To: T10 Technical Committee
From: Rob Elliott, HP (elliott@hp.com)
Date: 26 May 2004
Subject: 04-176r0 SBC-2 New CRC figure and example C code

Figure 1 — Even byte CRC generator bit order [CRC generator example \[new figure tool\]](#)

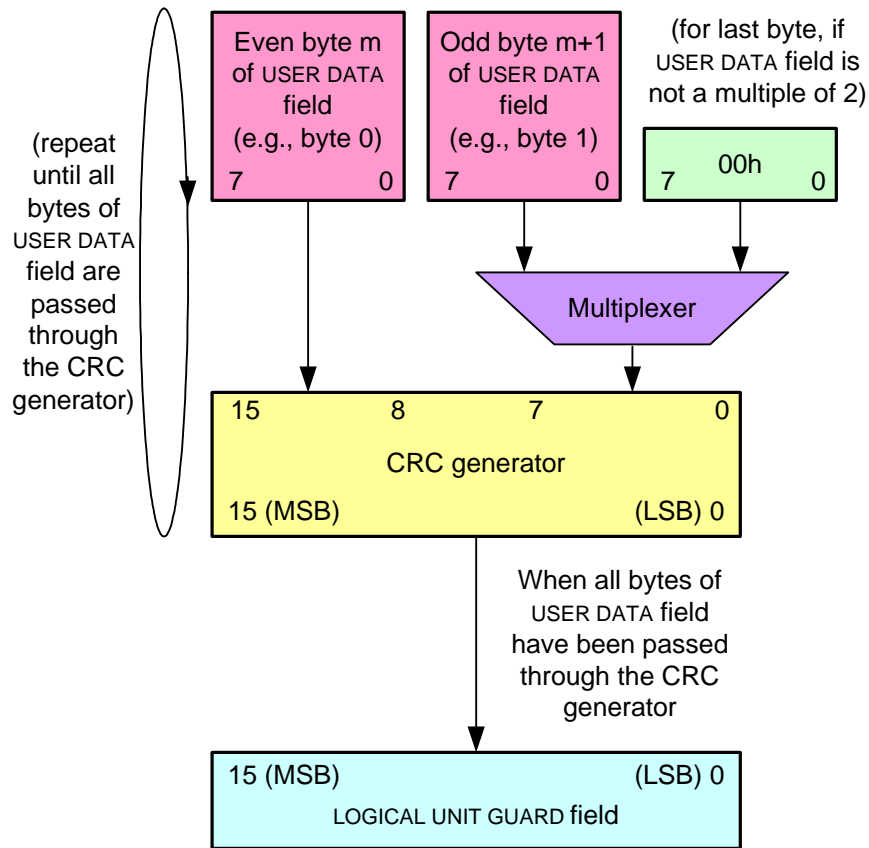
The endianness of the CRC figure in the data protection section has caused some confusion. It needs to be more clear that byte 0 and byte 1 are fed into the 16-bit CRC generator with byte 0 positioned to provide the most significant bit (MSB) and byte 1 to provide the LSB. Then, byte 2 and 3 are fed in with byte 2 containing the MSB and byte 3 containing the LSB, etc.

~~The bit order of $F(x)$ presented to the CRC function is two bytes at a time starting with byte zero bit seven of the USER DATA field until all the contents of the USER DATA field are processed. An example of an even byte-transfer CRC generation is shown in figure 3.~~

The CRC generator processes the USER DATA field one word (i.e., two bytes) at a time, starting with byte 0. In the first word, byte 0 bit seven is the MSB and byte 1 bit 0 is the LSB. Figure 3 shows an example CRC generator.
